MIL-T-60500A(MU)
AMENDMENT 3
15 December 1971
SUPERSEDING
AMENDMENT 2
11 February 1971

MILITARY SPECIFICATION

TRANSCEIVER: 10540501

This amendment forms a part of Military Specification MIL-T-60500A(MU), dated 22 September 1970.

FIGURE 3

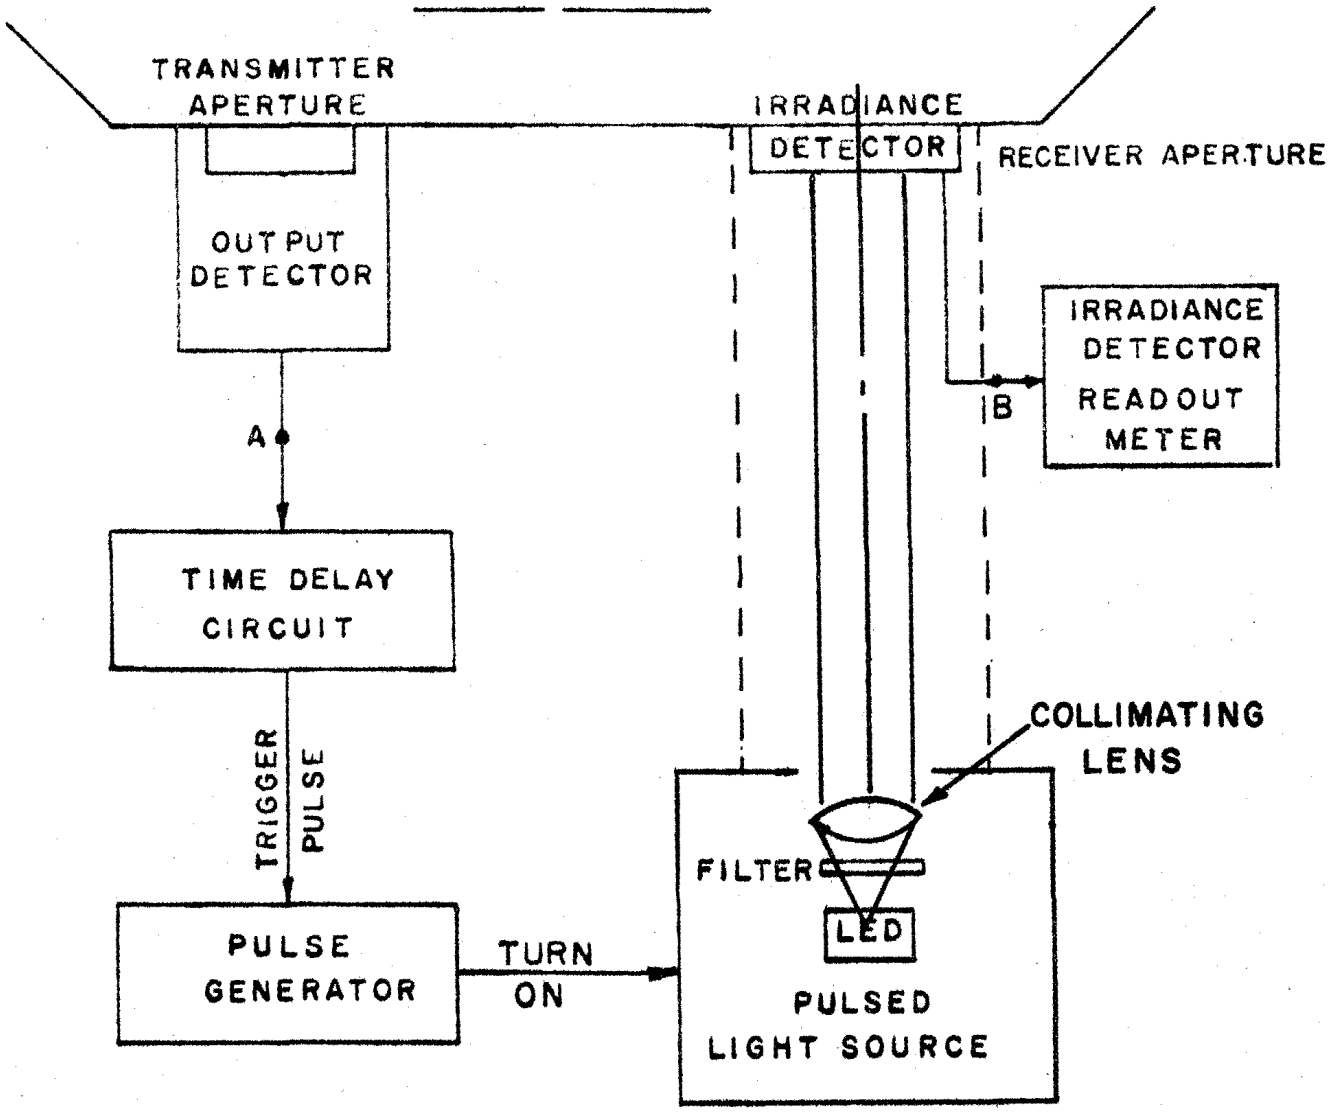
Figure 3: Delete and substitute attached Figure 3.

NOTE: * 1. MEASURE TIME DELAY FROM POINT "A" FROM OUTPUT DETECTOR TO POINT "B" FROM IRRADIANCE DETECTOR.

2. ISOLATE THE RECEIVER APERTURE TO PREVENT ERRONEOUS READINGS FROM REFLECTIONS FROM OUTPUT PULSE.
